**From:** Kubeczko, Dave  
**Sent:** Tuesday, November 03, 2009 9:56 AM  
**To:** Kubeczko, Dave  
**Subject:** FW: Yates Petroleum Big Hole Gulch Unit #2, SESE Sec 8 T11N R94W and Big Hole Gulch Unit #3, NWSE Sec 8 T11N R94W, Moffat County, Form 2A (#1712921 and #1712923) Reviews  
**Attachments:** doc20091103093725.pdf; doc20091103092237.pdf

I have been reviewing the Big Hole Gulch Unit #2 (#1712921) and Big Hole Gulch Unit #3 (#1712923) **Form 2As**. COGCC requests the following clarifications regarding the data Yates Petroleum Corporation has submitted on or attached to the Form 2As prior to passing the Oil and Gas Location Assessment.

# YATES PETROLEUM CORP.

BIG HOLE GULCH UNIT #2  
SECTION 8, T11N, R94W, 6th P.M.  
SE 1/4 SE 1/4

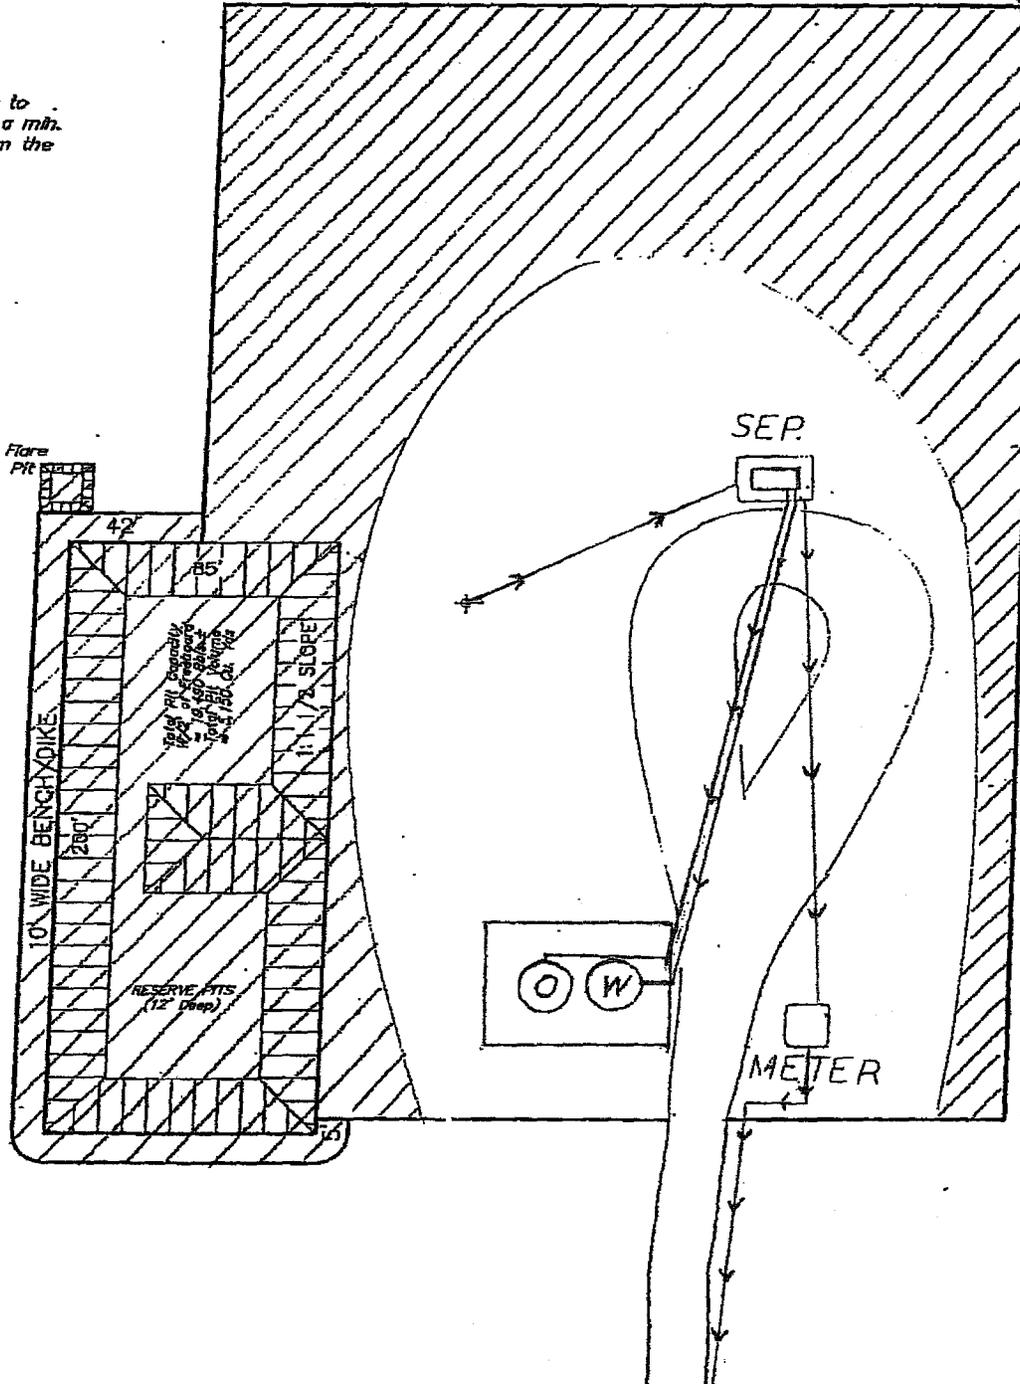
1. **Water Resources (Section 14):** Form 2A indicates the depth to groundwater to be 450 feet bgs for a well located 20000 (#1712921) and 29100 (#1712923) feet away from the proposed pads. COGCC's review indicates there is a water well (Permit No. 200734-BLM, stock well) located 11352 feet to the southwest, with a total depth of 570 feet bgs and a depth to groundwater of 302 feet bgs. I can make this change if you send me an email with this request.
2. **Rule 303.d.(3).C.:** Neither the scaled construction layout drawing (Figures 1) nor the Location Drawing (Figures 4) show the location of the proposed gas and water pipelines. One or both of these drawings should show the anticipated locations of these new facilities (hand drawn estimated locations would be sufficient, or the figures you submitted to BLM).

The pipeline will be following the access road please see attached drawings.
